Inspectors' Matters, Issues and Questions – April 2022

Matter 5: Is the Plan's approach to Metropolitan Open Land (MOL) justified, consistent with national policy, and in general conformity with the London Plan?

Council response:

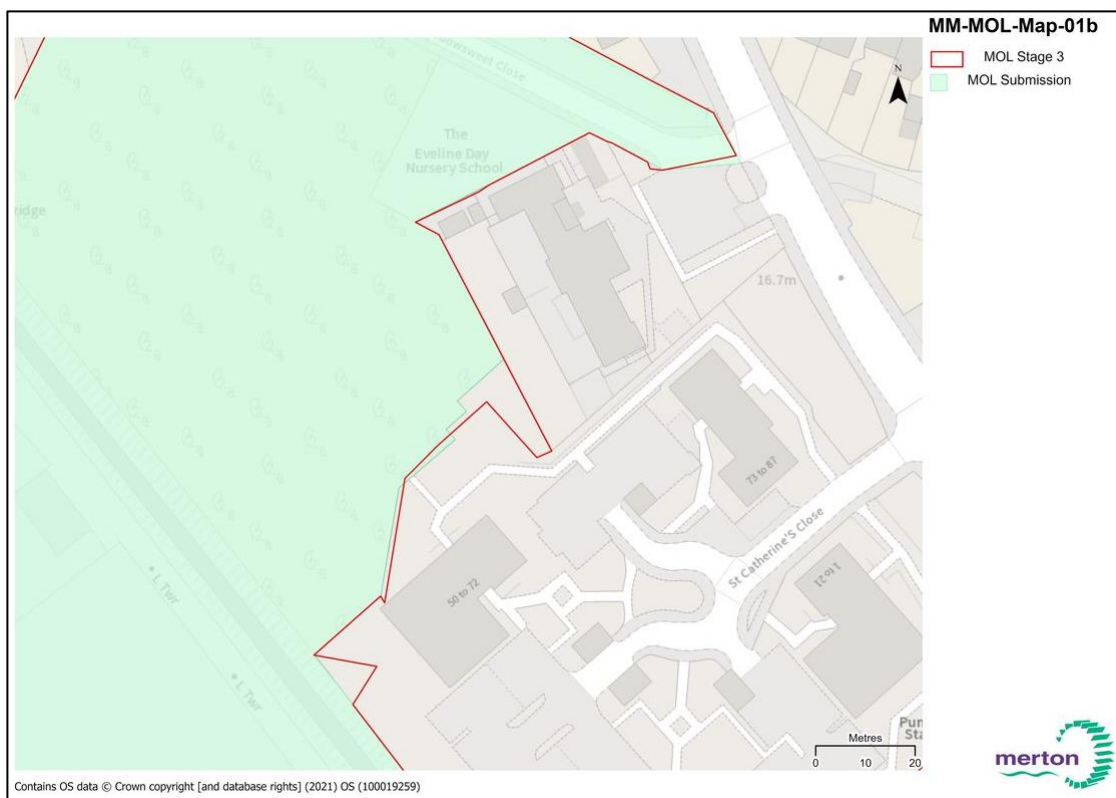
MM-MOL Map-01a - This site was brought to the attention of the council through correspondence from a resident looking to purchase one of the properties and requesting that the MOL status be re-considered as it was inappropriate for the site. Upon review, the MOL is considered to be an anomaly from the previous policy maps and the four residential properties should be removed to correct this error. The modifications ensure that the Local Plan is 'justified'. Refer to map below.

This modification proposes a boundary amendment to the MOL Policies Map, to remove the properties at 1, 2, 2a, 3 The Cottages, Lower Morden Lane SM4 4NU from Lower Morden Metropolitan Open Land (MOL-03). Refer to map below.
